INITIAL FIRE SAFETY INSPECTION REPORT

Habitus Fashion Limited- Extension Building

RSC ID: 25532

Date: 3rd September 2024

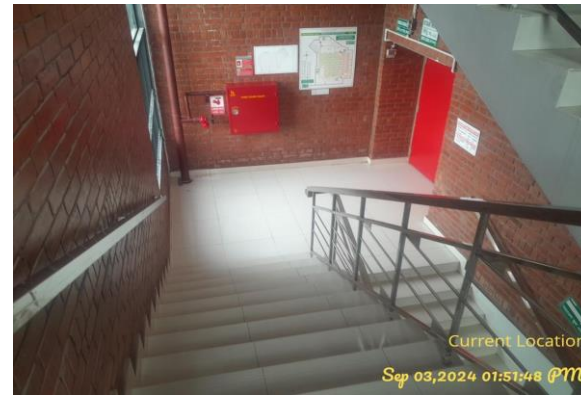
F-14	Means of Egress	Updated Building did not have stair designation signs & exit designation signs at required locations.	Provide Updated stair designation sign & exit designation sign at each floor entrance from the stair to the floor in English and Bengali. Signs shall indicate the name of the stair and the floor level. Signs shall be posted adjacent to the door.	Within 1 month
F-15	Means of egress	Uneven path of travel and blockage in exit discharge path due to construction purpose. Location: North side exit stair discharge path of 4-Storeyed finishing building.	Remove unnecessary items and level exit path to the public way. Means of egress shall be maintained continuously free and clear of all obstructions	Within 1 month
